Access Compliance Report

Public Rights-of-Way

(Curb Ramps)

Intersection ID: 8277	Main Street: GOFF_ST	Cross Street: GOSSETT_AV	Location: SW
ADA ID: 88AE2053C8E2	Ramp Type: Perp	Initial Pass/Fail: Fail	Overall Compliance: No
		Severity Score: 25

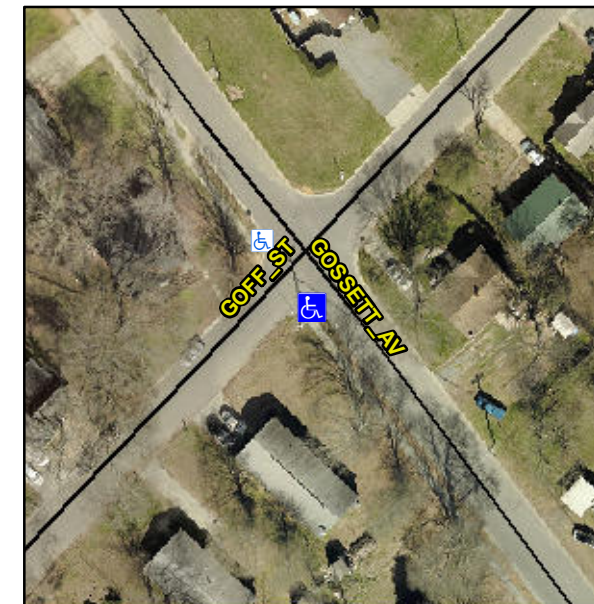
Not Found, R304.2.2, R304.5.3

Compliance	Description	Data	Compliance	Description	Data
N/A	Ramp Length (in)	87.0	No	Ramp Slope (%)	8.7
Yes	Ramp Width (in)	48.0	No	Ramp XSlope (%)	5.6
N/A	Flare Type LT	N/A	N/A	Flare Type RT	N/A
N/A	Flare Slope LT (%)	N/A	N/A	Flare Slope RT (%)	N/A
N/A	Flare Traversable LT?	N/A	N/A	Flare Traversable RT?	N/A
N/A	Landing Length (in)	N/A	N/A	DWS Provided?	N/A
N/A	Landing Width (in)	N/A	N/A	DWS Contrast?	N/A
N/A	Landing Slope (%)	N/A	N/A	DWS Length (in)	N/A
N/A	Landing X Slope (%)	N/A	N/A	DWS Full Width?	N/A
N/A	Landing Curb? (Y/N)	N/A	N/A	DWS Offset (in)	N/A
N/A	Shared Landing?	N/A			
N/A	Gutter Ponding?	N/A	N/A	Gutter Slope (%)	N/A
N/A	Gutter Lip Ht (in)	N/A	N/A	Gutter X Slope (%)	N/A
N/A	Painted X Walk1?	No	N/A	Painted X Walk2?	N/A
	X Walk 1 Direction	To N		X Walk 2 Direction	N/A
N/A	X Walk 1 Width (in)	N/A	N/A	X Walk 2 Width (in)	N/A
	X Walk 1 Slope (%)	0.3		X Walk 2 Slope (%)	N/A
	X Walk 1 X Slope (%)	5.3		X Walk 2 X Slope (%)	N/A

Remove & Replace Entire Ramp.
